Parkside Cemetery -- Dundas Information Session Tuesday, February 19, 2019

My comments / some thoughts on the design:

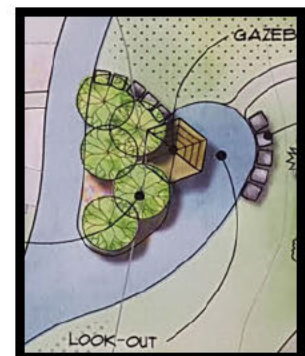
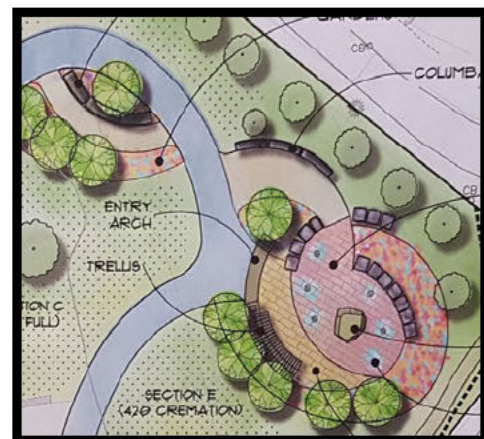
The Columbarium Areas are situated nicely along the paths that are intersected by the main asphalt path and leads smoothly to the commemorative rock area. But the western-most columbarium, with the outward convex curve, should be located on the other side of that pathway and curved inwards (concave) so as to look more inviting. The staggered locations would also offer greater visual variety and interest.

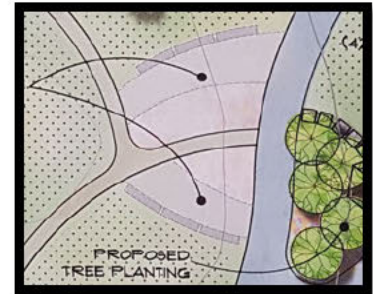
The 'Look-out' should have minimal vegetation impeding the vista of anyone situated in the gazebo looking out towards the Driving Park. At most, any proposed vegetation should be low-lying in the foreground. Perhaps taller vegetation may be used to 'frame' selected views.

The rock seating wall can be utilized as a bottom frame in the foreground for viewers situated in the gazebo, but sitters on the rock wall will have the option of sitting and viewing the scenery towards the gazebo or outwards into the Driving Park.
